**ADDENDUM No. 2**  
**Request for Competitive Sealed Proposals (CSP)**  
**19CSP104 Renovations at Dobie Middle School**

**Addendum No. 2**

**TO:** Prospective Bidders  
**FROM:** Haddon+Cowan Architects  
**SUBJECT:** AISD Dobie Middle School Renovations

**DATE:** February 15, 2019  
**HCA PROJ. NO:** 18-1032  
**AISD PROJ. NO:** 190035-DOBIE

**1** GYM CRAWL SPACE NEW PLAN  
M3.2 1/8"=1'-0"

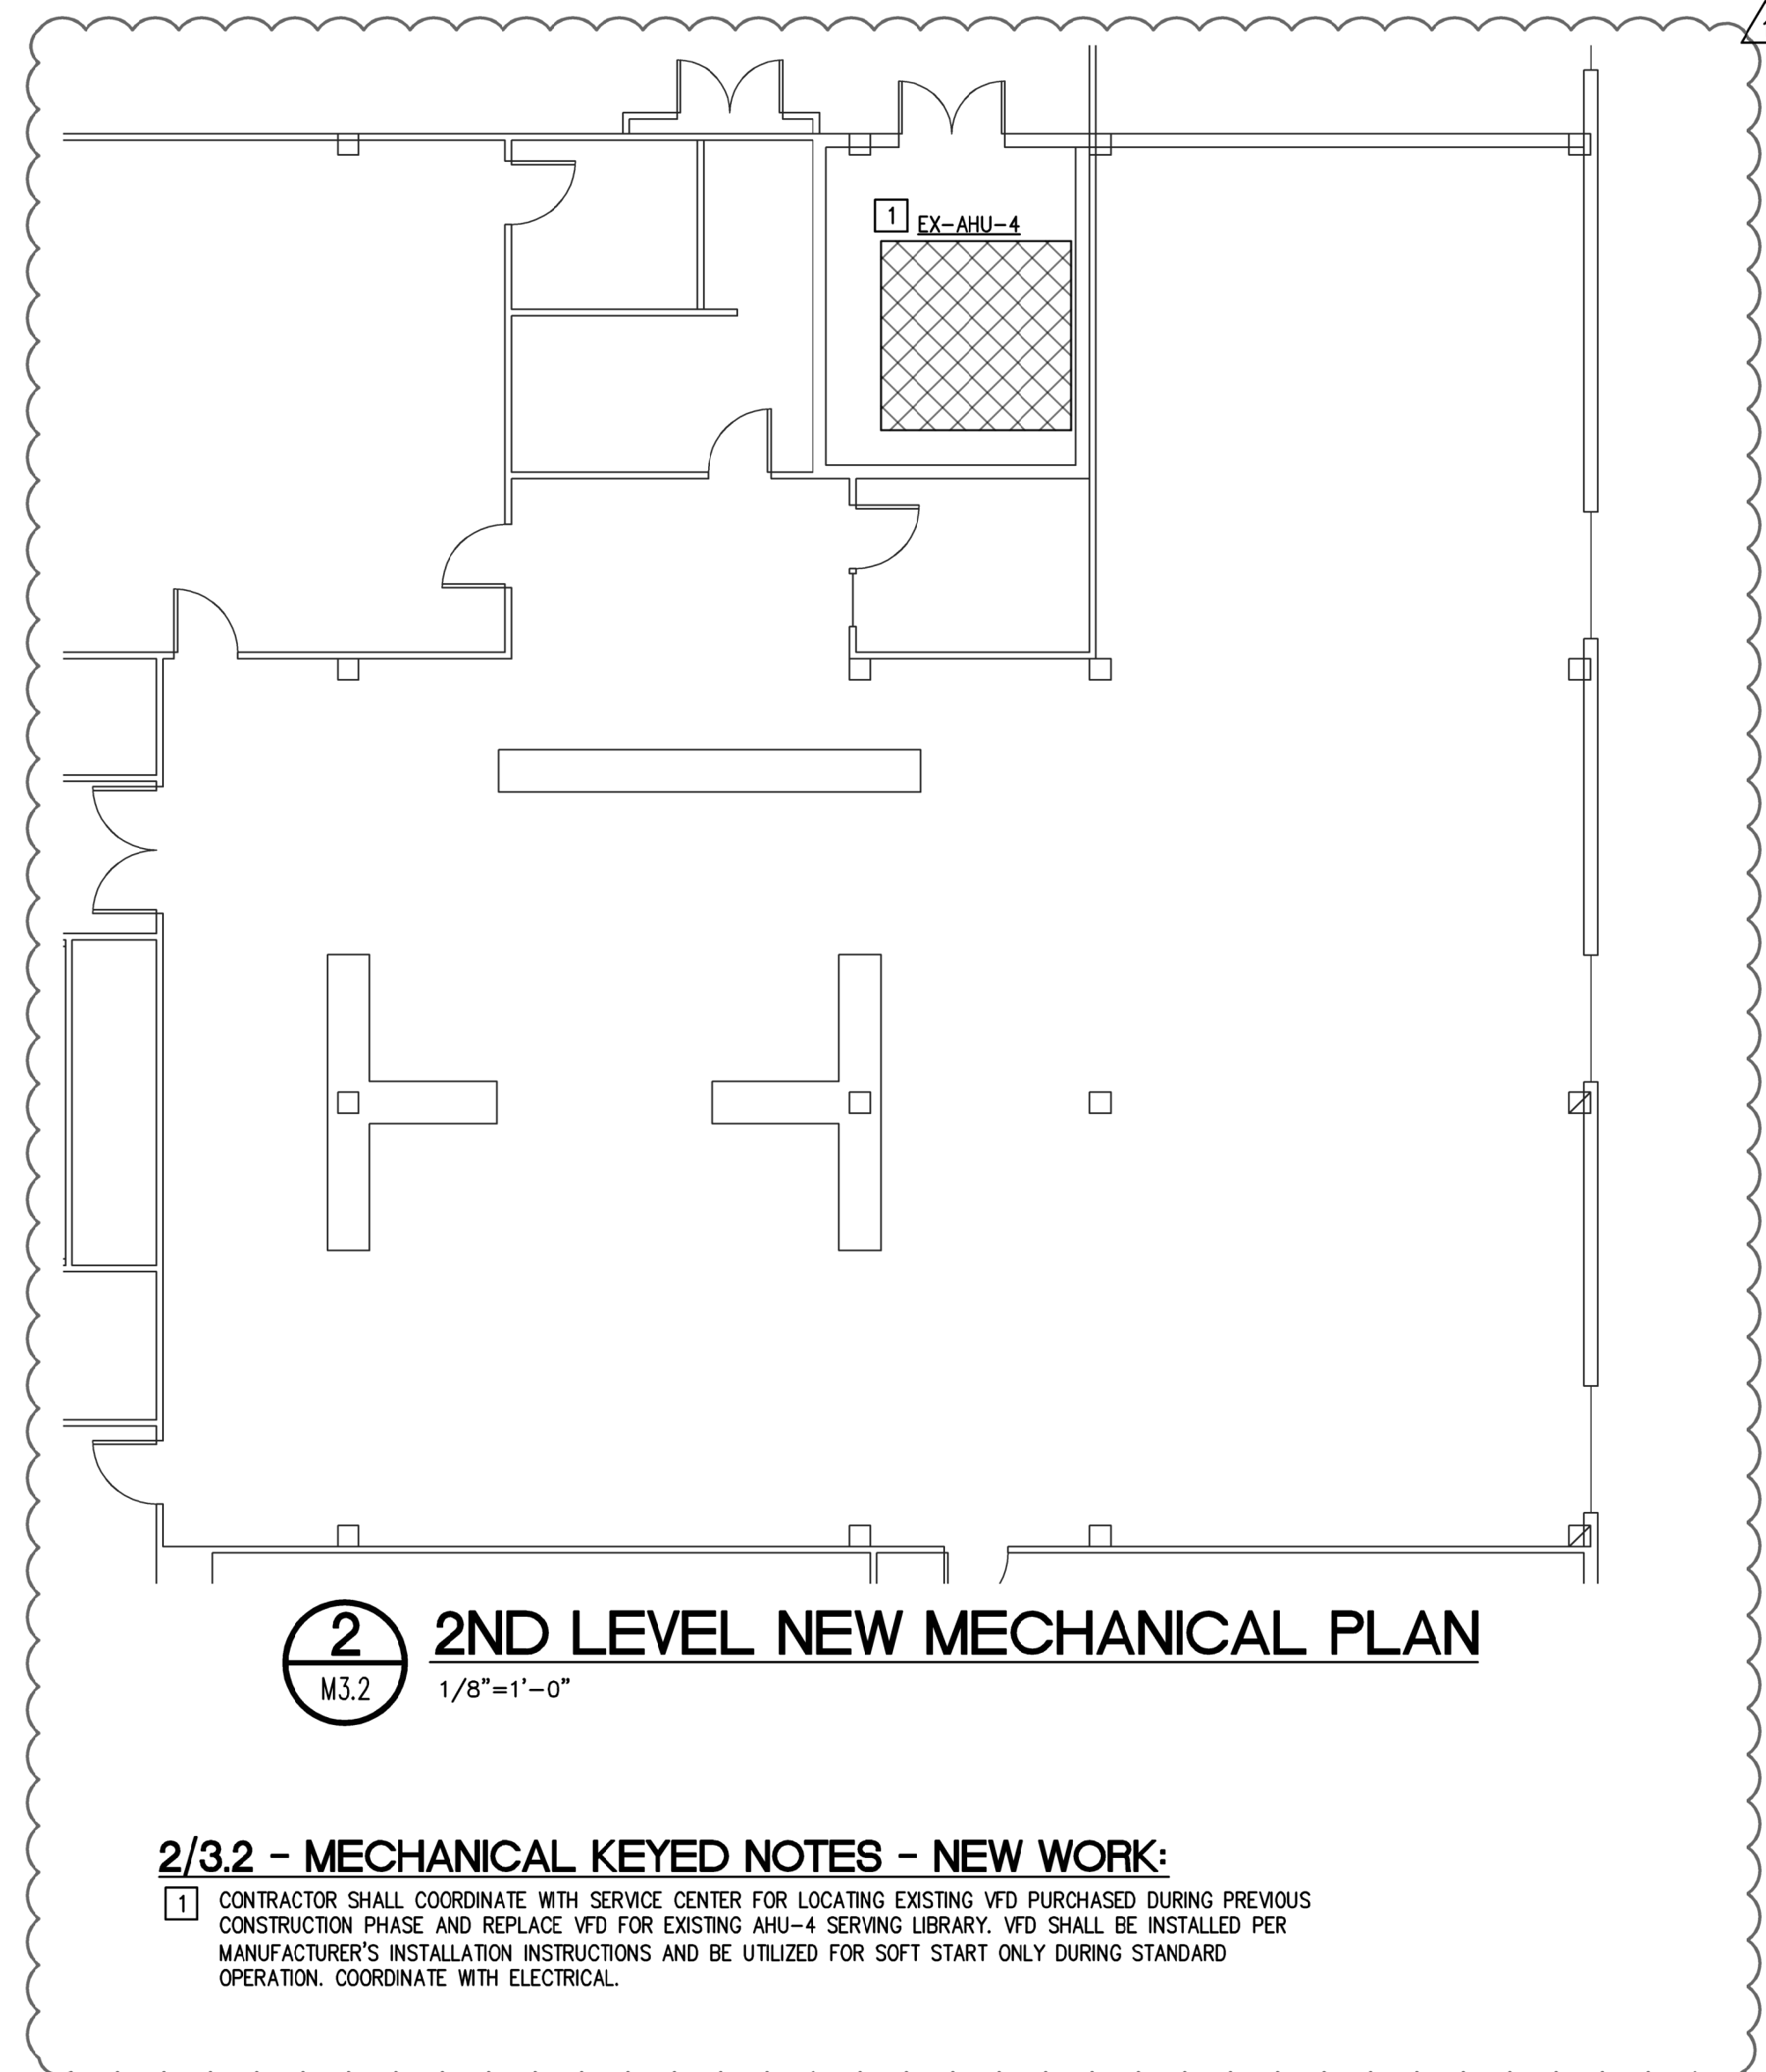
- b. New plan has been added to show existing AHU-4 location and noted to include replacement of VFD for unit utilizing VFD purchased during previous construction phase.

- 1** CONTRACTOR SHALL COORDINATE WITH SERVICE CENTER FOR LOCATING EXISTING VFD PURCHASED DURING PREVIOUS CONSTRUCTION PHASE AND REPLACE VFD FOR EXISTING AHU-4 SERVING LIBRARY. VFD SHALL BE INSTALLED PER MANUFACTURER'S INSTALLATION INSTRUCTIONS AND BE UTILIZED FOR SOFT START ONLY DURING STANDARD OPERATION. COORDINATE WITH ELECTRICAL.

**1 MAIN MECHANICAL ROOM DEMO PLAN**  
E3.1 1/4"=1'-0"

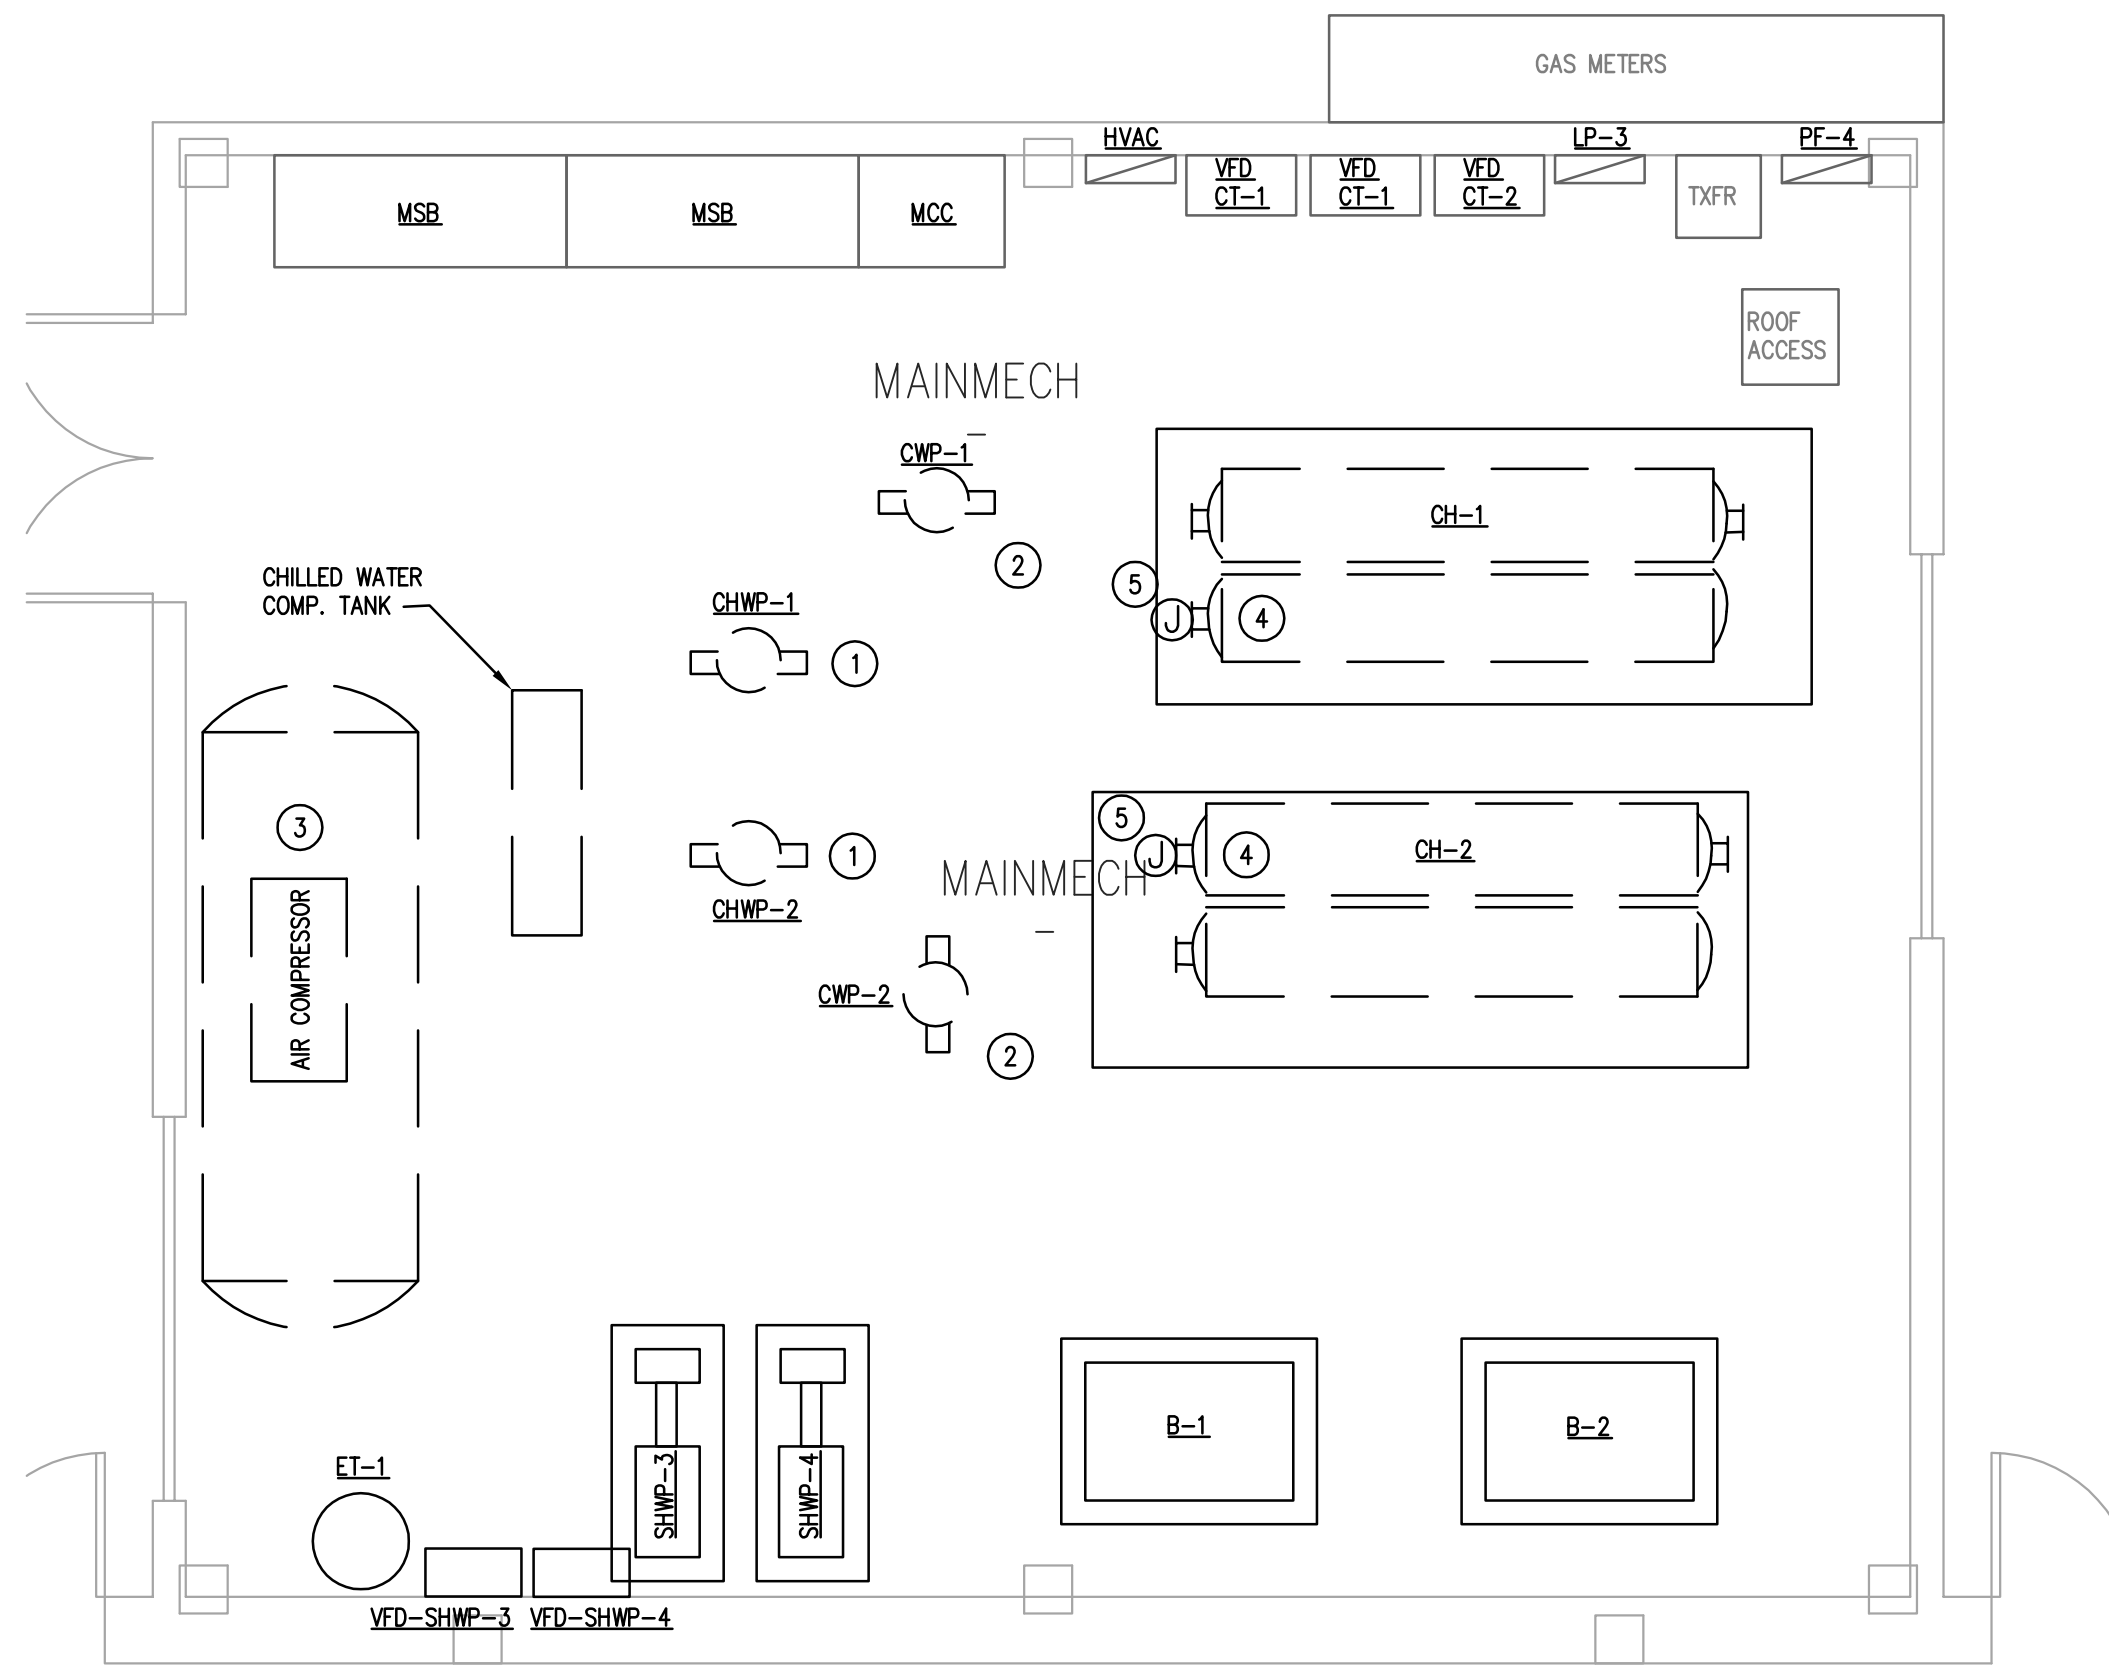
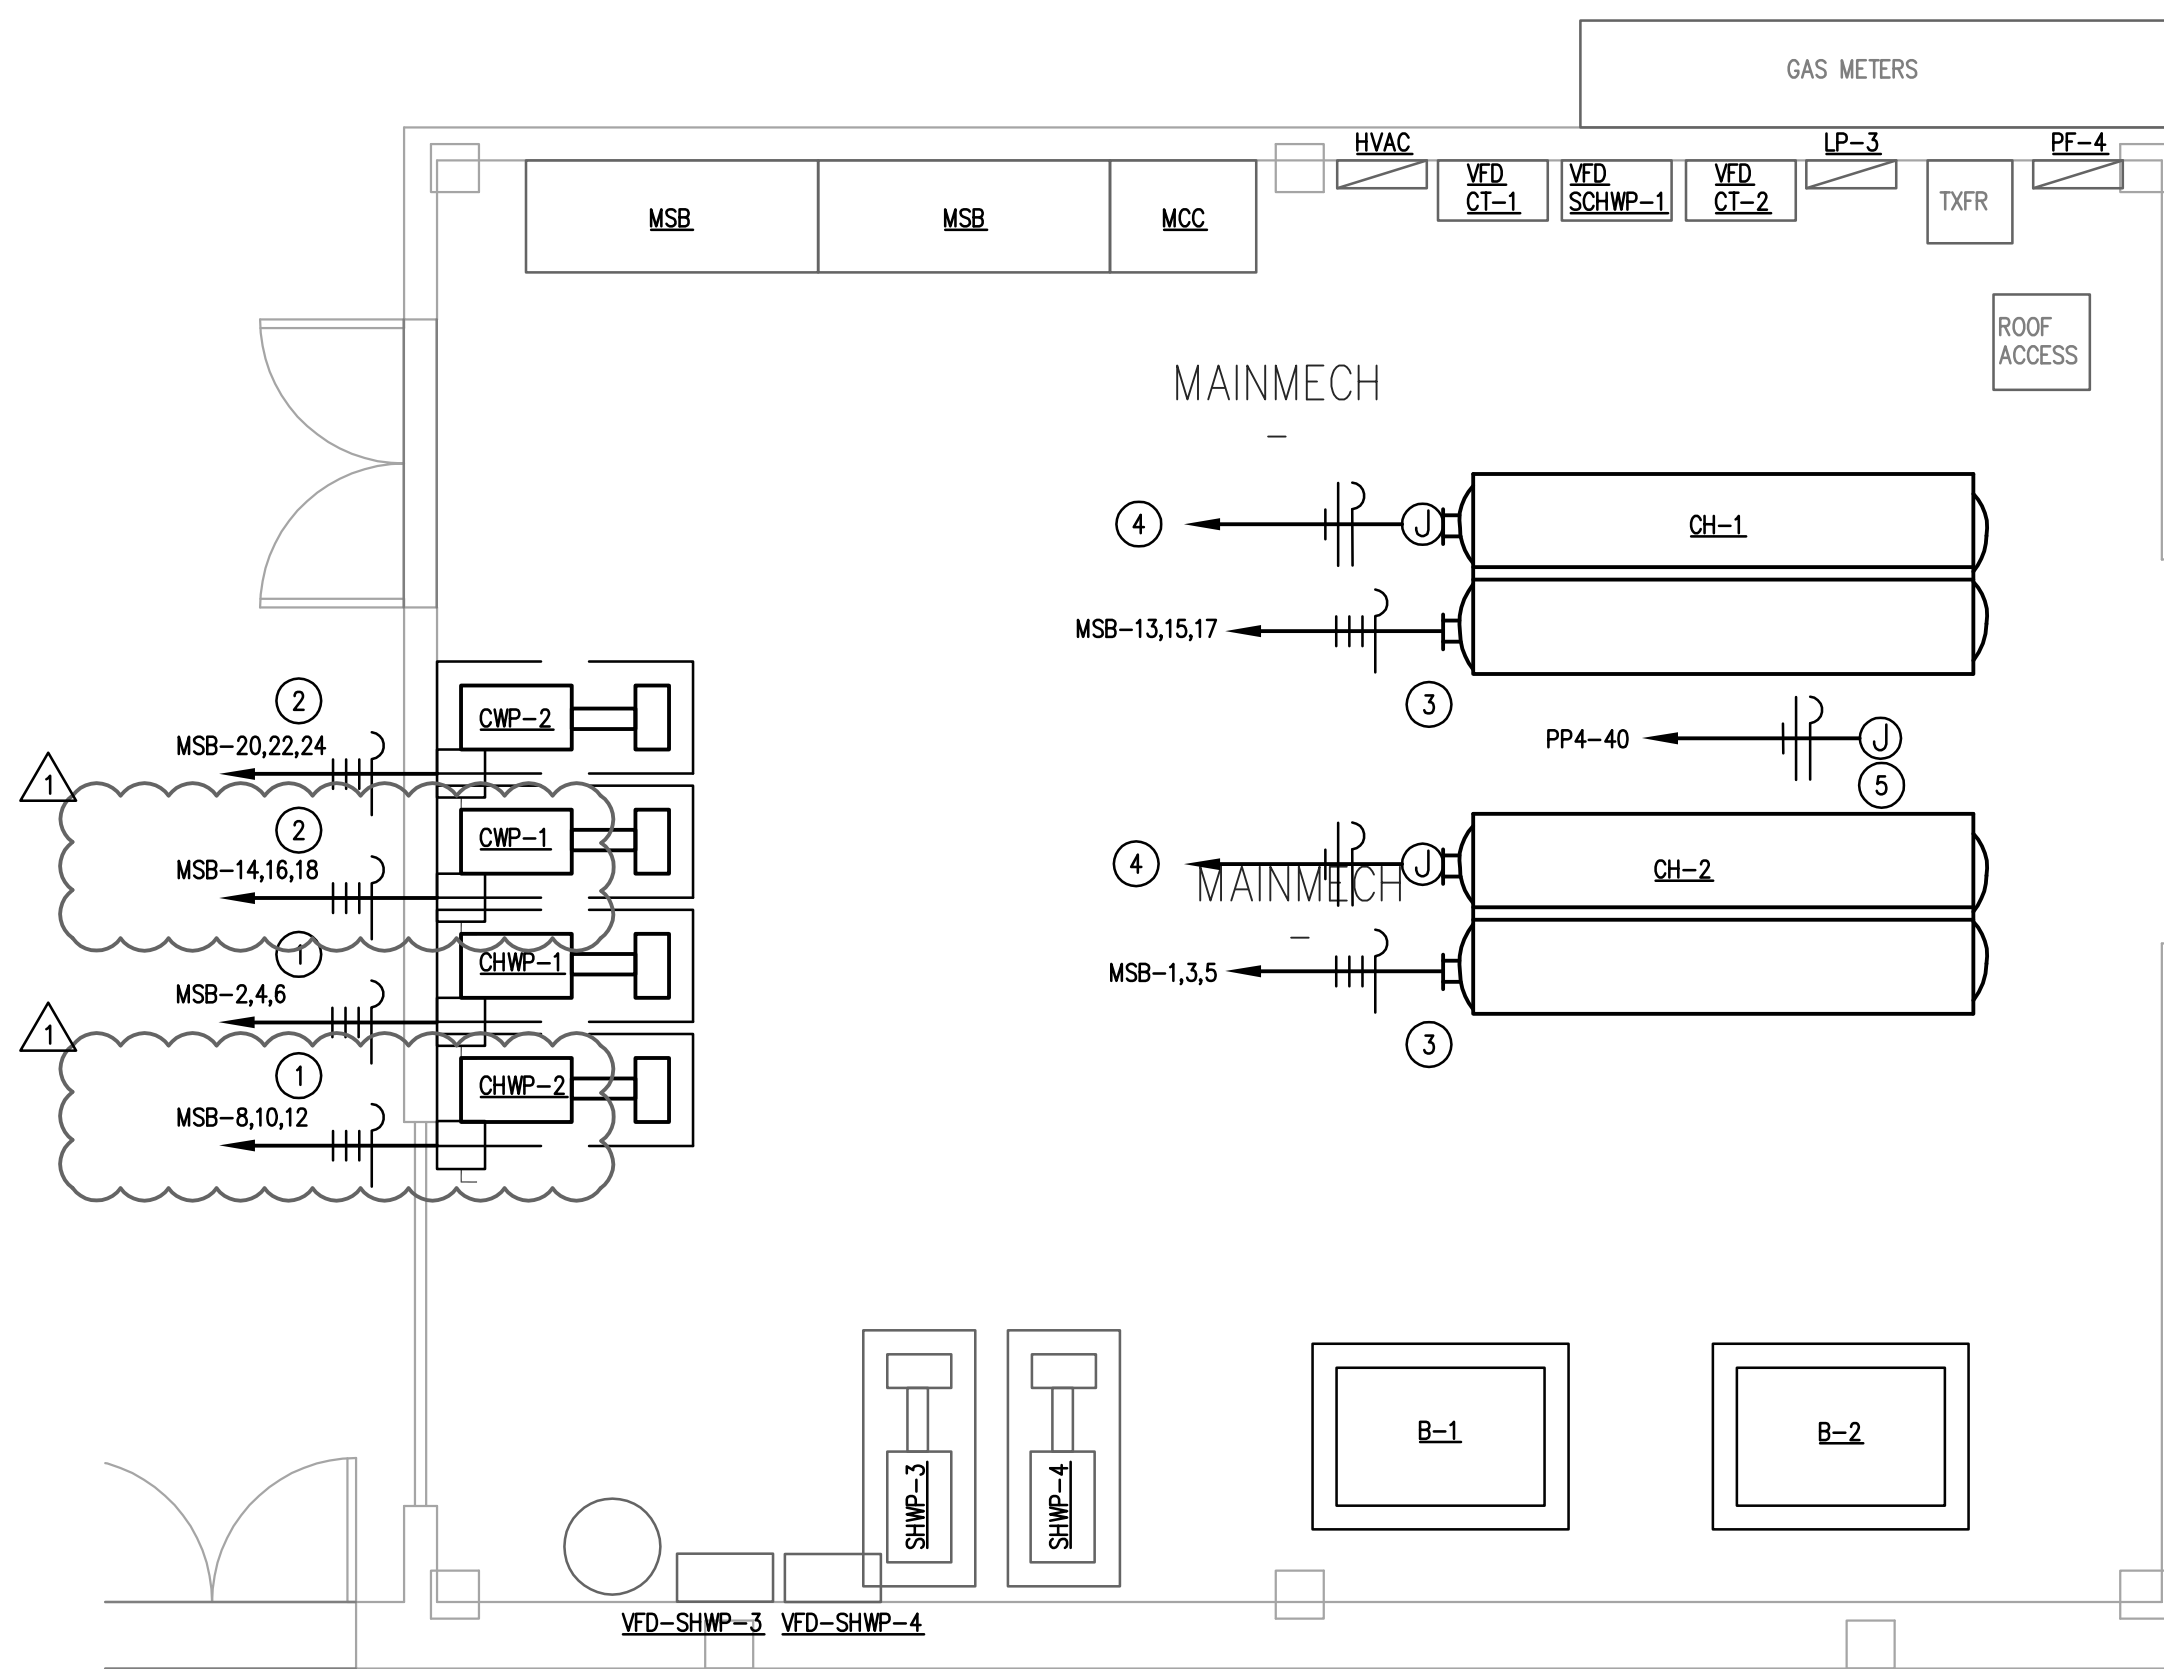
13. Sheet M5.1 – Revised and Reissued
- a. CHWP-1,2 have been revised to show lower HP rating.
14. Sheet E3.1 – Revised and Reissued
- a. Relocated CWP-1 & CHWP-2 to match mechanical plans.

- b. Updated emolition keyed note 4.
  - c. Detail 2: Updated keyed notes 1 & 2 for use of new VFD, not existing.
  - d. Added Detail 3 and keyed notes for replacement of AHU-4 VFD.

- ① CONTRACTOR SHALL COORDINATE WITH SERVICE CENTER FOR LOCATING EXISTING VFD PURCHASED DURING PREVIOUS CONSTRUCTION PHASE AND REPLACE VFD FOR EXISTING AHU-4 SERVING LIBRARY. VFD SHALL BE INSTALLED PER MANUFACTURER'S INSTALLATION INSTRUCTIONS AND BE UTILIZED FOR SOFT START ONLY DURING STANDARD OPERATION.
- ② ELECTRICAL CONTRACTOR TO REUSE EXISTING WIRE, CONDUIT & CIRCUIT BREAKER SERVING EXISTING AHU-4. VFD SPECIFICATIONS SHALL HAVE THE CAPACITY TO SERVE AHU-4. COORDINATE WITH SERVICE CENTER, AHU MANUFACTURER, VFD MANUFACTURER & ENGINEER OF RECORD PRIOR TO INSTALLATION UPON VFD & CIRCUIT CAPACITY NOT MEETING AHU REQUIREMENTS, AISD IS PAY FOR MEP DESIGN AND CONTRACTOR INSTALLATION OF SERVICE CENTER VFD.
